# UNITED STATES PATENT AND TRADEMARK OFFICE

APPLICATION NO.	FILING DATE	FIRST NAMED INVENTOR	ATTORNEY DOCKET NO.	CONFIRMATION NO.
10/595,460	04/20/2006	Jangshik Yun	2017-075	9993
53706 7590 07/17/2009				
IPLA P.A. 3580 WILSHIRE BLVD. 17TH FLOOR LOS ANGELES, CA 90010				
EXAMINER				
WU, IVES J				
ART UNIT		PAPER NUMBER		
1797				
MAIL DATE		DELIVERY MODE		
07/17/2009		PAPER

**Office Action Summary****Application No.**

## **DETAILED ACTION**

FIGURE 1

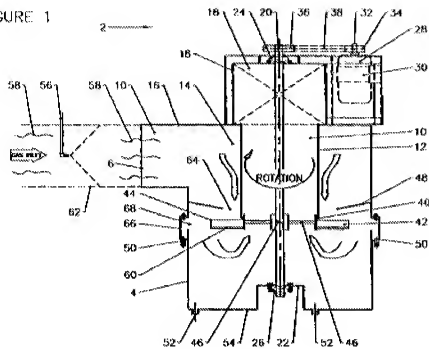
As to wet type air cleaner utilizing a centrifugal impeller comprising: a body 407 in which a centrifugal impeller 408 rotates the sucked air, to which a housing and a gas passage cylinder 413 are mounted so that a vortex having a centrifugal force lengthwisely passes by a predetermined distance in **independent claim 14**, Rosen (US 7077886B2) discloses emission control device and method of operation thereof (Title). It relates to an emission control device to remove particulates from a gas and, more particularly to an emission control device that operates by adding moisture to the gas and subsequently removing moisture from the gas along with particulates. Still more particularly, it relates to a scrubber with a fan located therein (Col. 1, line 10-15). As is shown in the Figure below, it has housing 4; blower (fan) 42; passage 10; which meet the limitations as claimed.

As to the body having an annular 1<sup>st</sup> vortex room formed between the housing 409 and the gas passage cylinder 413 and a 2<sup>nd</sup> vortex room formed in the gas passage cylinder 413 in **independent claim 14**, as shown in the Figures above the annular passage which reads on the 1<sup>st</sup> vortex room, the passage 10 within the concentric section reads on 2<sup>nd</sup> vortex room.

As to over driver 436 utilizing with various transfer means including an oil surface friction transmission, a gear transmission et al for increasing the rotation speed of a centrifugal impeller 408 in **claim 17**, Rosen (US 7077886B2) discloses the belt 38, pulleys 34, 36 to drive the shaft 20 of the fan as shown in the Figure of Rosen (US 7077886B2) above.

As to a scrubbing room 406 located on the gas suction duct 405 for scrubbing gas pollutants with the stream of a fine particular liquid mist in **claim 18**, as shown in Figure above the section before the gas inlet passage 10 would be a scrubbing section.

As to a centrifugal impeller 408 utilizing with a turbine impeller for generating centrifugal vortex stream in a gas-liquid centrifugal separator 407 in **claim 23**, as shown in the Figure of Rosen above, the outer blades 44 reads on the limitations as claimed.

As to an impeller shaft 435 formed with a gas passage inside for passing a clean gas through inside of a shaft in **claim 25**, as shown in the Figure above, the shaft 20 and gas passage 10, which reads on limitations as claimed.

FIGURE 3

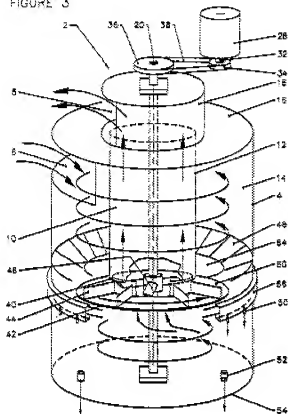
As to wet type air cleaner utilizing a centrifugal impeller with a liquid atomizer and a gas-liquid centrifugal separator for disposing an electric motor outside of a gas-liquid centrifugal separator comprising: an electric motor 433 installed on the outside of a gas-liquid centrifugal separator 407, an over driver 436 connected with an electric motor 433, an impeller shaft 435 rotatably fixed with an over driver 436, a centrifugal impeller 408 rotatably fixed on an impeller shaft 435, and a bearing 434 supported for a centrifugal impeller 408 on a gas passage cylinder 413 in **claim 24**, as shown in the Figure above, moisturizer 56, emission control device 2, the motor 28, pulley 34, belt 38, shaft 20, bearing 24, blower 42, gas passage 10, which read on the limitations as claimed.

As to spiral grooves 416 formed on the outside surface of a gas passage cylinder 413 for generating vortex stream of wet gas on the basis of labyrinth effect and separating washing water from gas on the basis of centrifugal force in claim 16, Rosen (US 7077886B2) discloses the annular baffles at lower end of annular passage as shown in the Figure 4 above. Rosen **does not teach** the spiral grooves as claimed.

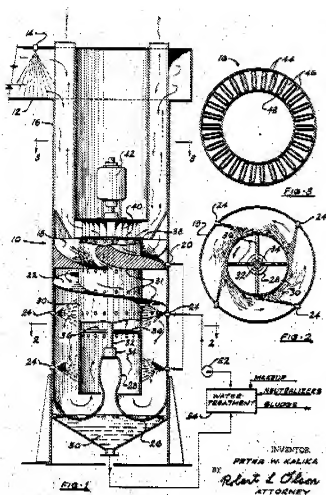
However, Kalika (US 3358413) **teaches** wet scrubber for dirty gases (Title). As illustrated in the Figure below, the spiral baffle 22 which reads on limitations as claimed.

The advantage of spiral baffles is to further stabilize and ensure the spiral flow pattern (Col. 2, line 16-17).

Therefore, it would have been obvious at time of the invention to install the spiral groove disclosed by Kalika for the annular passage in the device of Rosen in order to attain the advantage cited herein above.
